JLRTB02043NAS3
TECHNICAL BULLETIN
30 JAN 2023

501-08

Air Deflector Loose/Adrift

MODEL:	MODEL YEAR:	VIN:	ASSEMBLY PLANT:
I-PACE (X590)	2019-2020	F60001-F90422	Graz (Austria)

3.

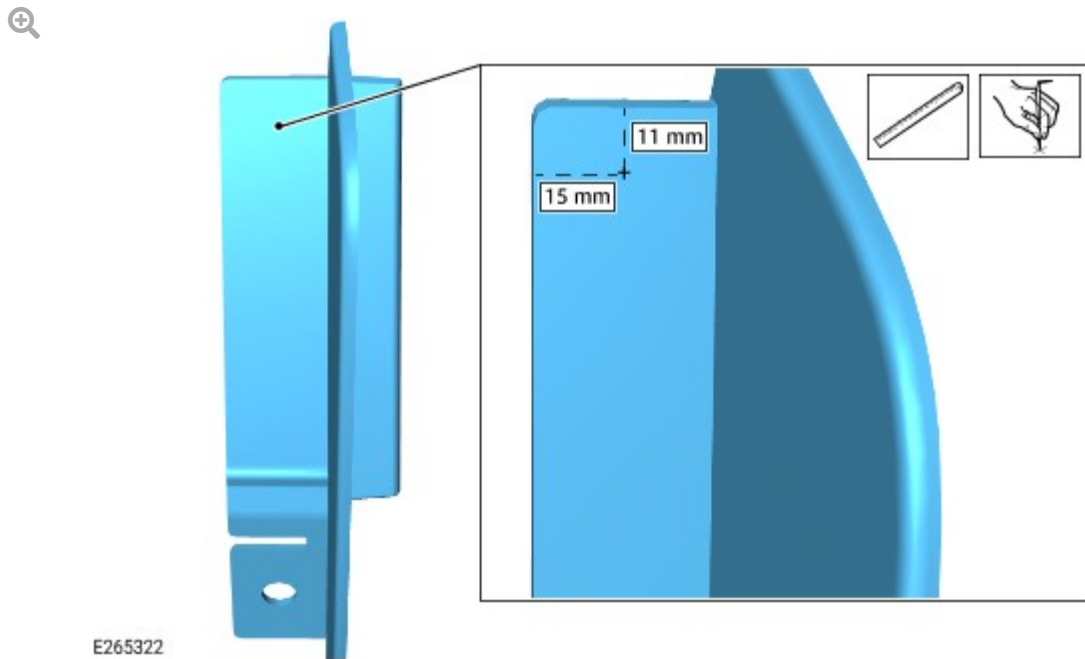
Measure and mark the position on the left air deflector for drilling, as shown in the illustration.

4.

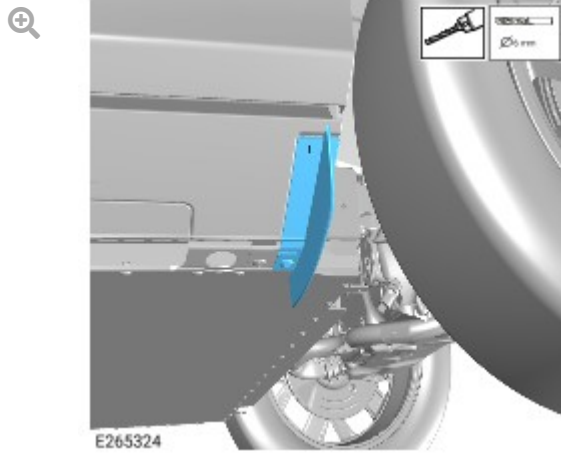
Using a 6 mm drill, create a hole through the left air deflector and the left rocker panel molding in the position marked during step 3.

6.

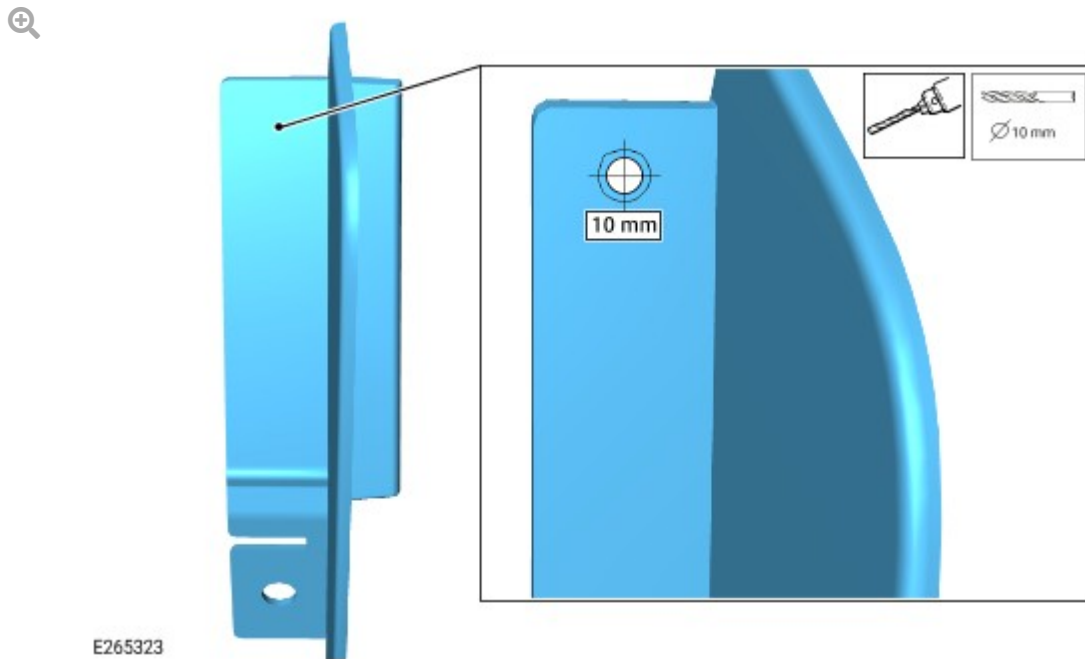
Using a 10 mm drill, increase the size of the new hole in the left air deflector from 6 mm to 10 mm.

7.

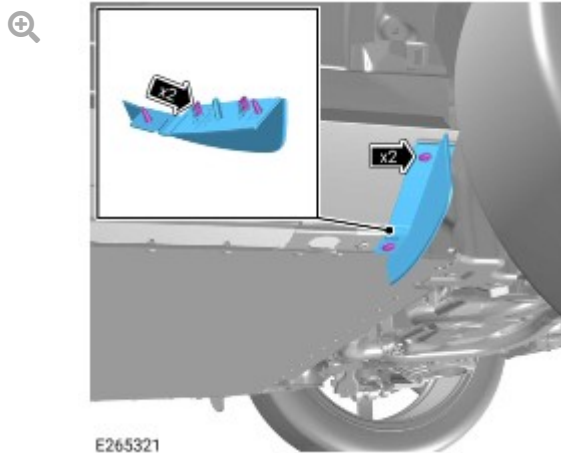
Install the left air deflector.

- Secure the 2 retaining clips.
- Secure the 2 retaining screws.
